FINAL DRAINAGE REPORT

Ferranti Residence, 2290 Old Ranch Road, Colorado Springs, Colorado
Lot 8, Block E, Amended Filing of Springs Crest Subdivision
El Paso County, Colorado

November 1, 2023

DESCRIPTION: **HISTORIC DRAINAGE FERRANTI RESIDENCE 2290 OLD RANCH ROAD**

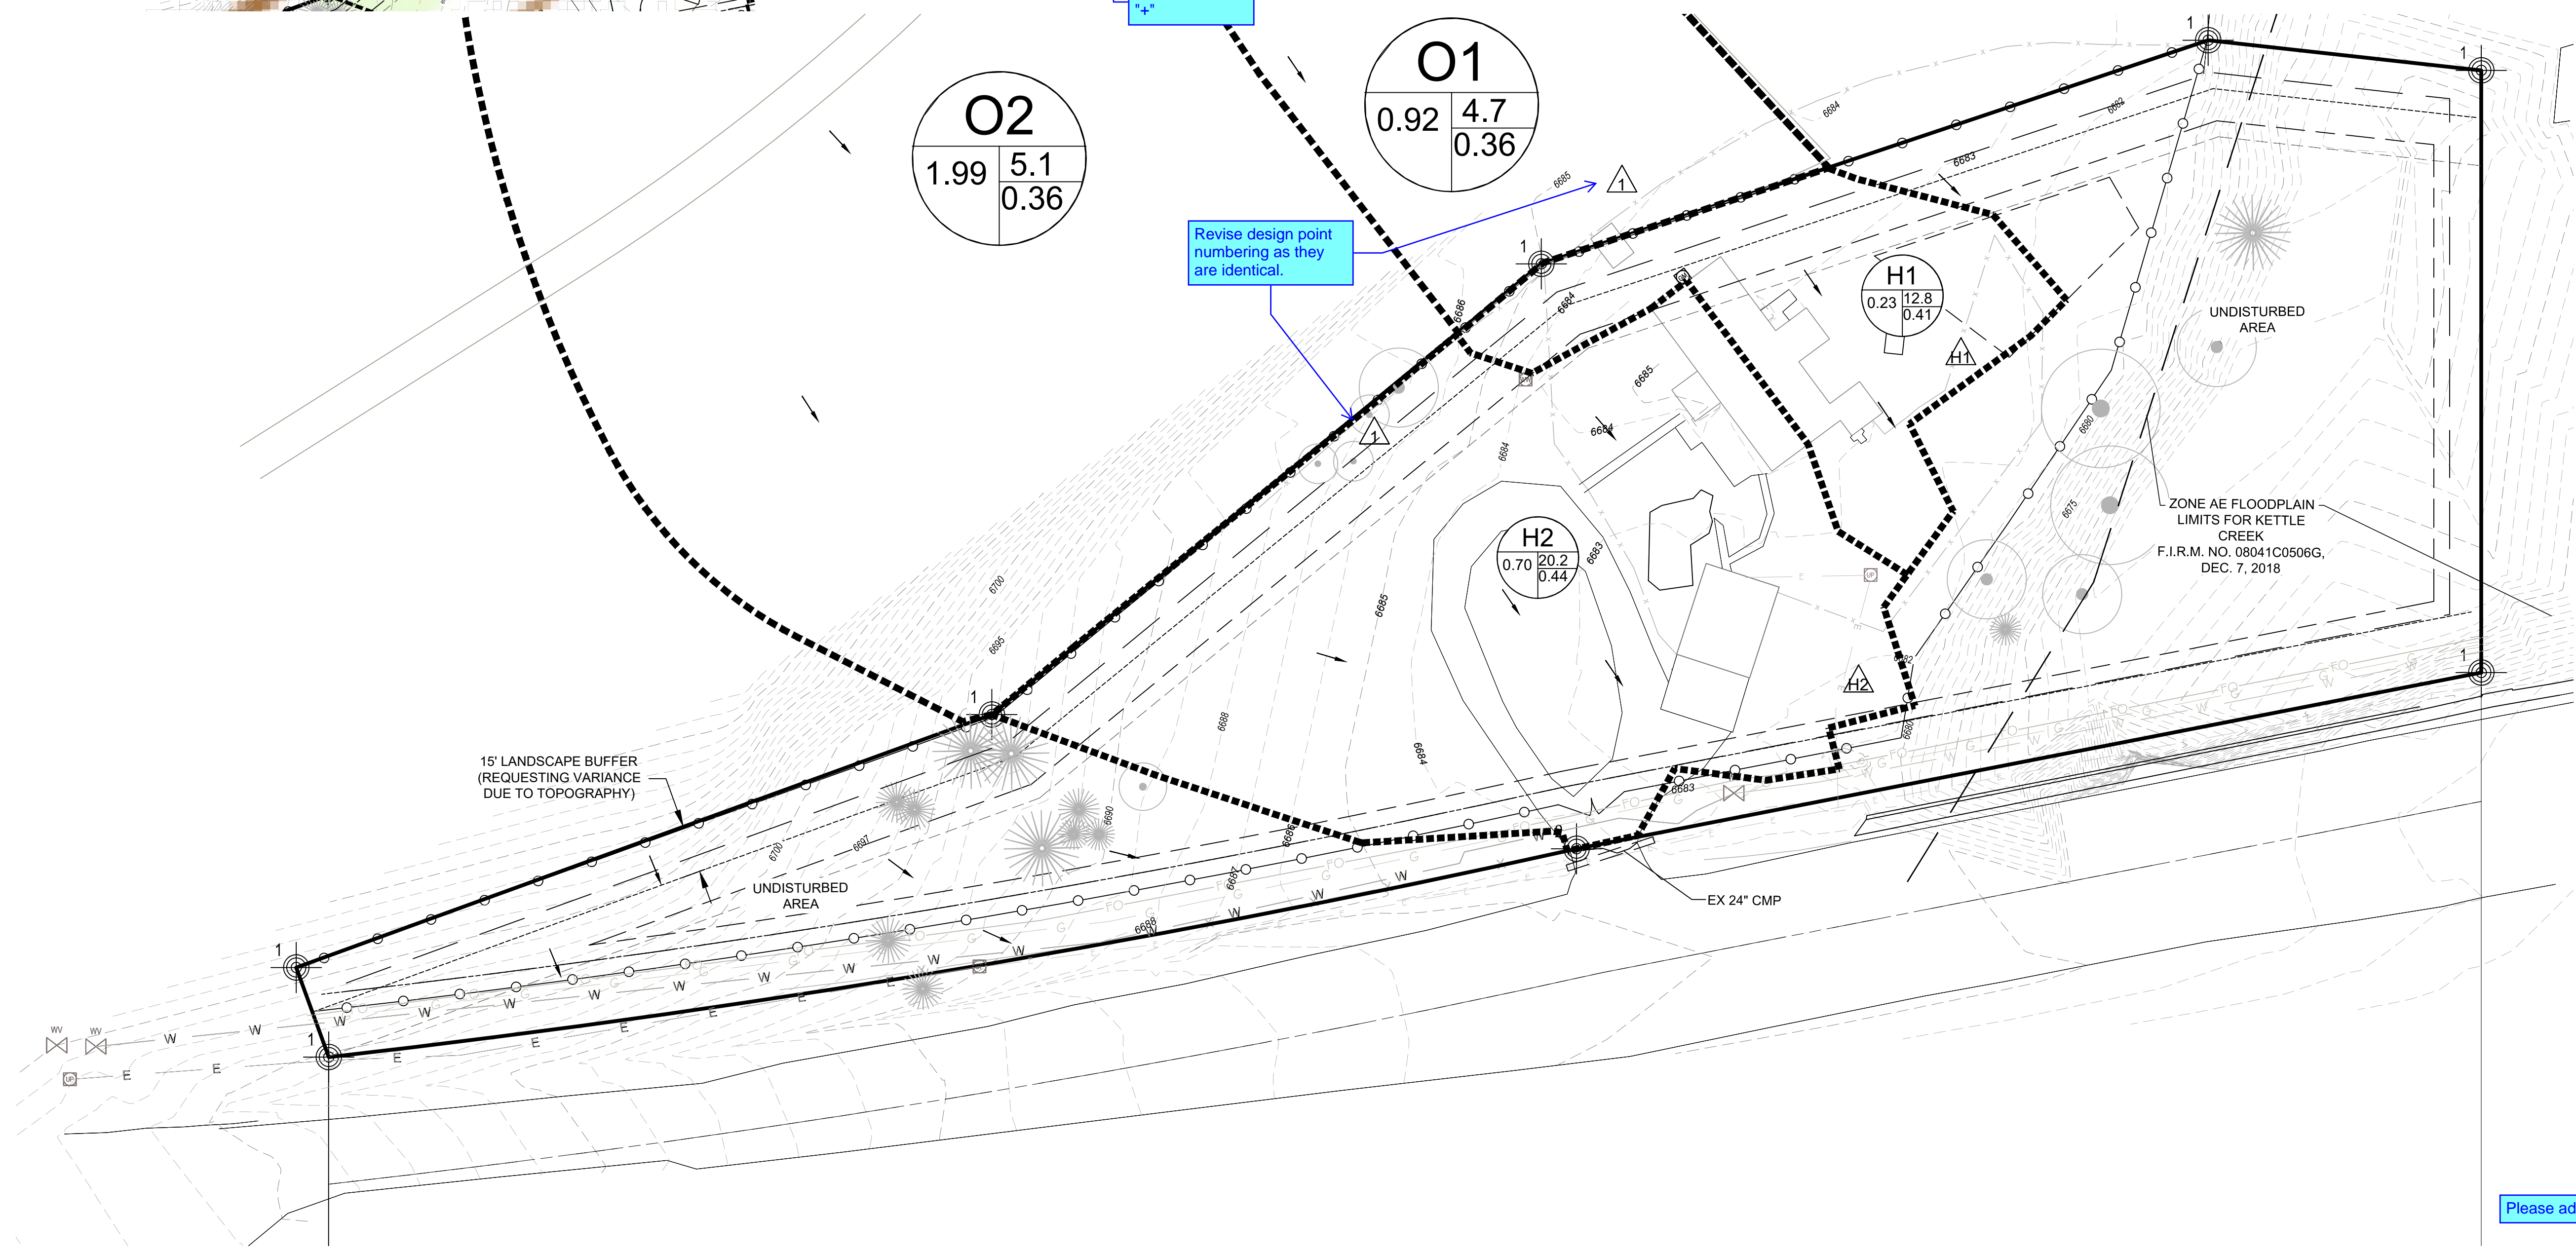
Please add "PCD File No. CDR2320"

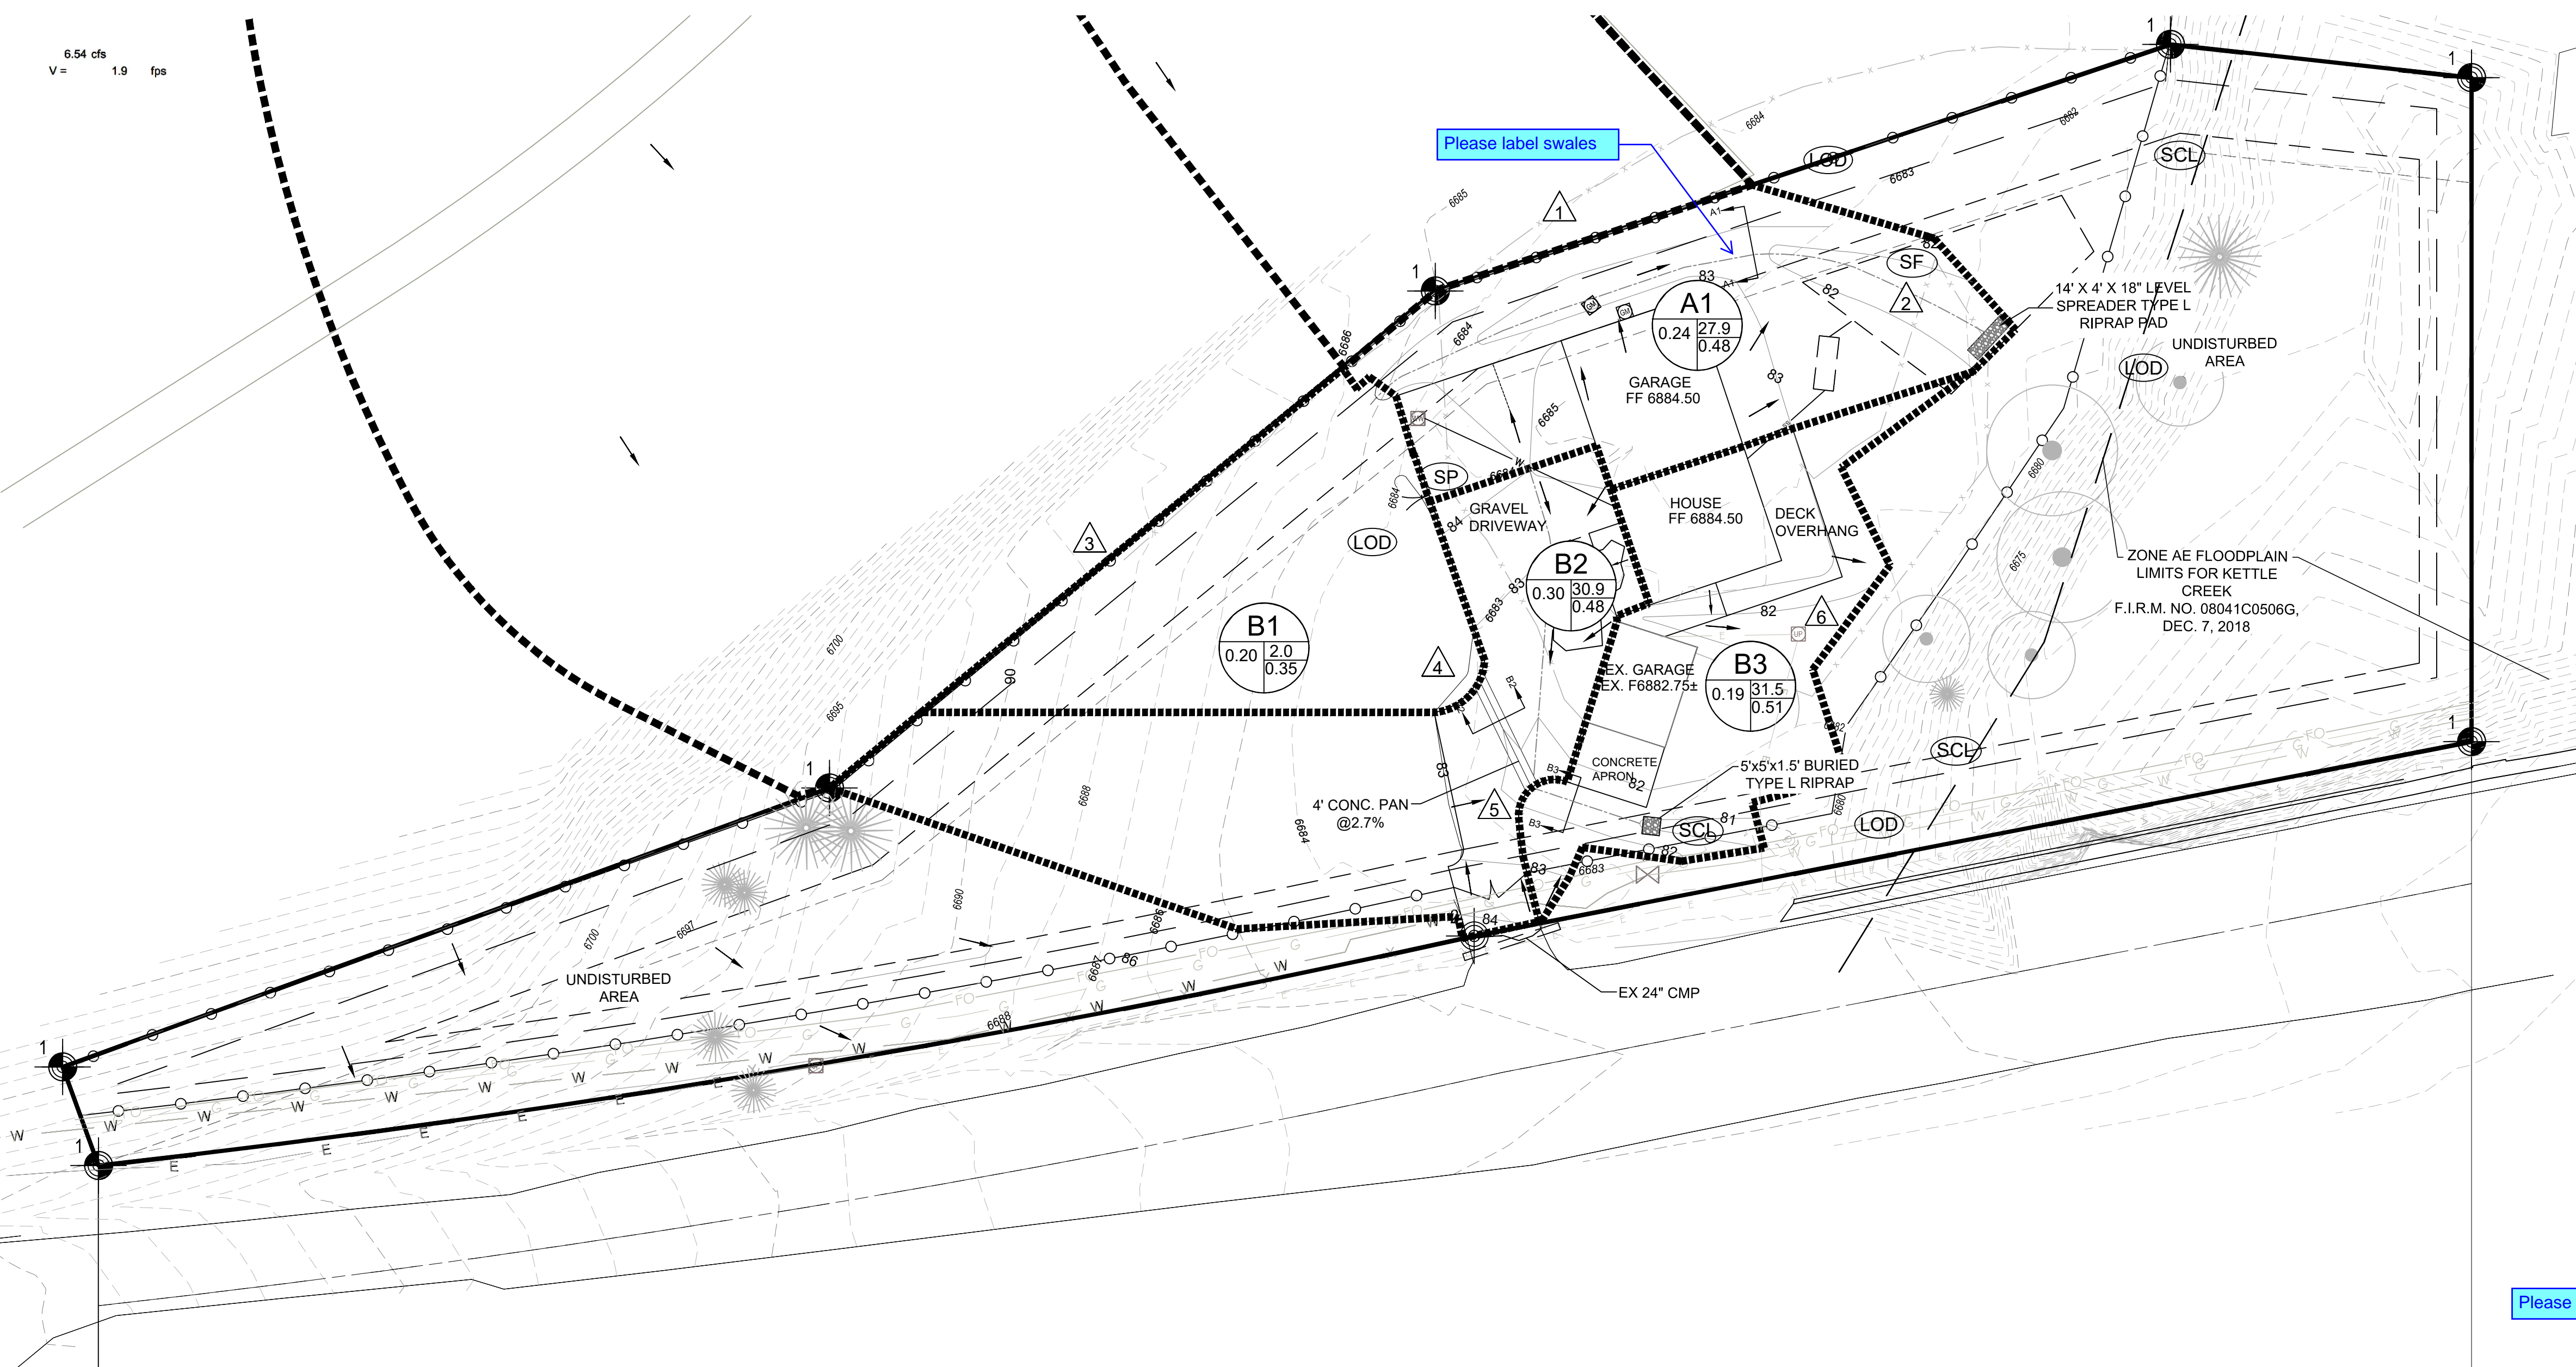
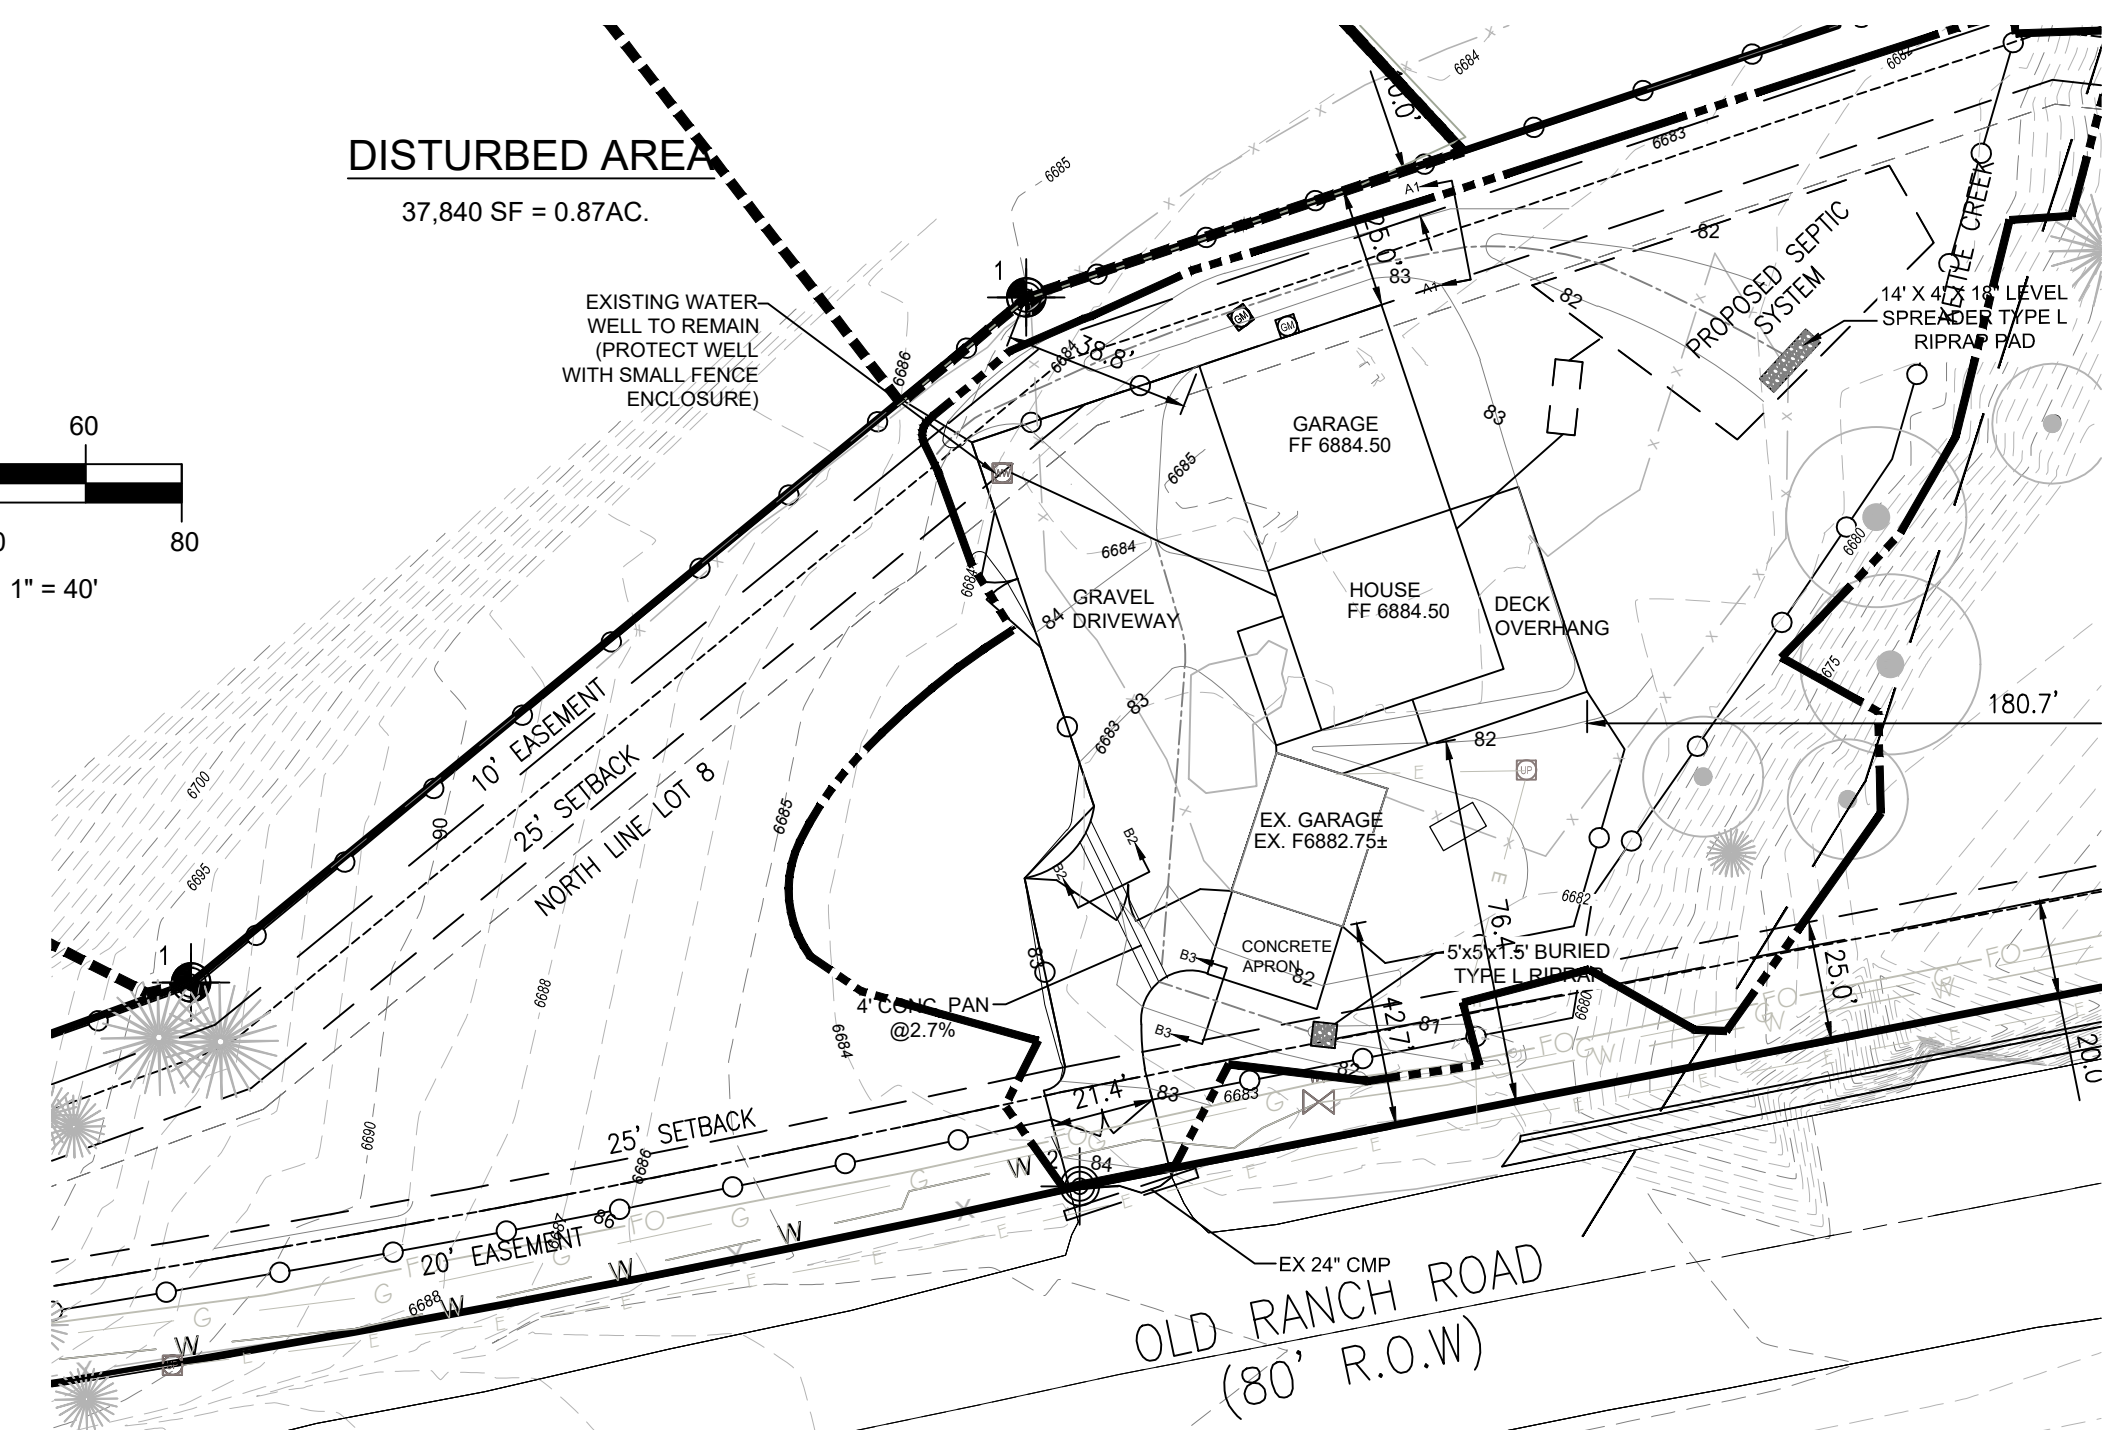
Please add "PCD File No. CDR2320"
